# **Bell Helicopter** **TEXTRON**

## **INFORMATION LETTER 206-02-86**

**SUBJECT: MAIN ROTOR FLAP RESTRAINT KIT 206-706-013 CHANGE IN INSTALLATION PROCEDURE**

Figure 1 Support 206-010-191

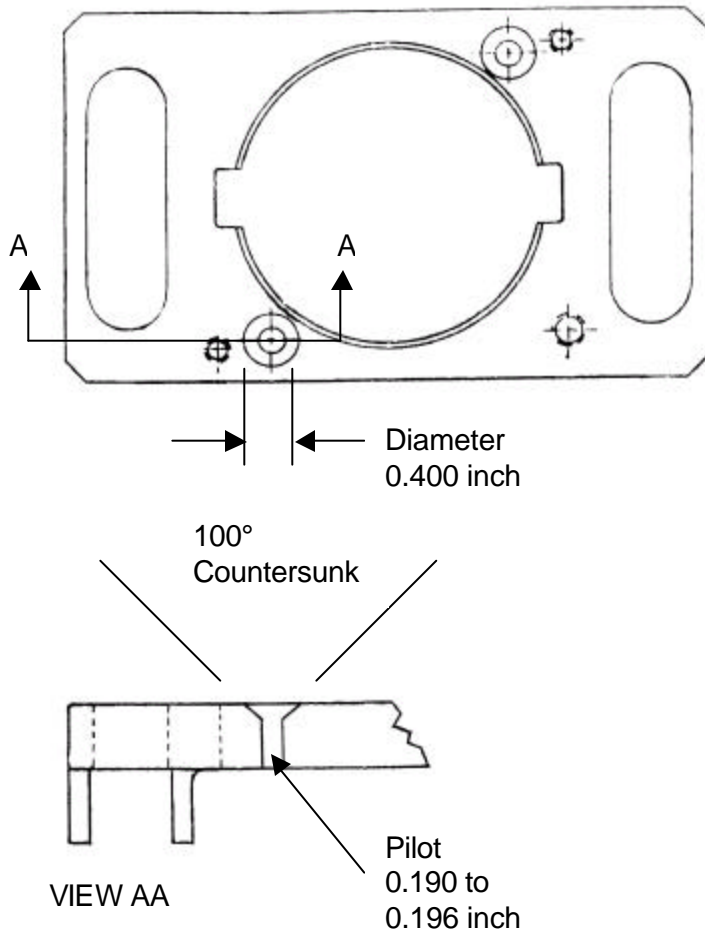
Bell Helicopter has learned of a possible interference between the flap restraint support attaching screws and the mast nut. This Information Letter is issued to advise of this condition and provide the recommended remedial action.

One of two conditions may contribute to this potential interference. Some 206-010-191 supports may have been manufactured with the countersinks for the attaching screws not deep enough. Primer or paint may have been applied to the plate, reducing the dimension of the attachment screws countersink.

Either of the above conditions may cause the screw head to protrude above the surface and foul the mast nut when the mast nut is tightened. This condition is not a safety issue but the protruding screws head may damage the mast nut and in extreme conditions affect the mast nut torque.

Use a straight edge placed on the screws head to ensure the screw heads do not protrude above the support. If the screws head protrude, check the support countersinks for presence of primer or paint. Remove any primer or paint from the countersinks, and repeat the straight edge check. If a screw head is found to protrude after the paint removal, rework the support as follows:

1. Using a press drill and a 100° countersink bit with a 0.190 to 0.196 inch diameter pilot, machine the countersink as shown in figure 1.
2. After rework brush cad plate the countersink. Do not apply primer or paint to the countersink surfaces.
